CITY OF ALBUQUERQUE

RE: **Enterprise Rent-a-Car**
3500 Coors Blvd NW
Conceptual Grading and Drainage Plan
Engineer's Stamp Date: 1/11/19
Hydrology File: G11D038

Based on the submittal received on 1/11/19, the Conceptual Grading and Drainage Plan is approved for Site Plan for Building Permit. Based on the information provided, Hydrology does not anticipate drainage infrastructure on this project.

PROJECT TITLE
ENTERPRISE RENT-A-CAR
3500 COORS BLVD NW
ALBUQUERQUE, NEW MEXICO 87120
JOB NO.
2018028
PROJECT MANAGER
JEFF WOOTEN
DRAWN BY
CW
SHEET TITLE
Grading Plan

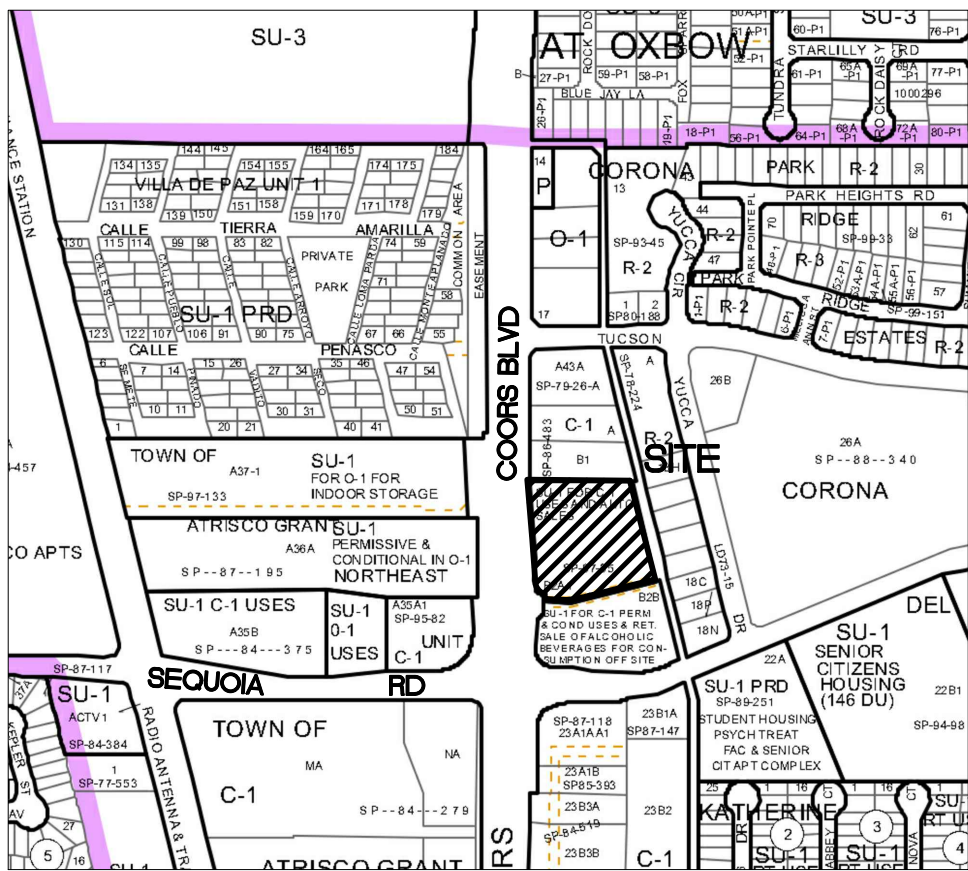
1. Remove all "Conceptual" markings.
2. Quantify the area of redeveloped impervious (repaving and the building addition) and the area of disturbance.
3. Calculate the Storm Water Quality Volume (SWQV) requirement, based on the redeveloped impervious area. Demonstrate that the new stormwater pond will capture the equivalent stormwater quality volume from impervious areas.
4. If the disturbed area will exceed 1 acre, this project will require an ESC Plan, submitted to the Stormwater Quality Engineer (Curtis Cherne PE, ccherne@cabq.gov or 924-3420).

5. Engineer's Certification, per the DPM Chapter 22.7: *Engineer's Certification Checklist For Non-Subdivision* is required.
6. A Bernalillo County Recorded [Drainage Covenant \(No Public Easement\)](#) is required for the stormwater control pond and the existing Stormwater Quality Pond. The original notarized form, exhibit A (legible on 8.5x11 paper), and recording fee (\$25, payable to Bernalillo
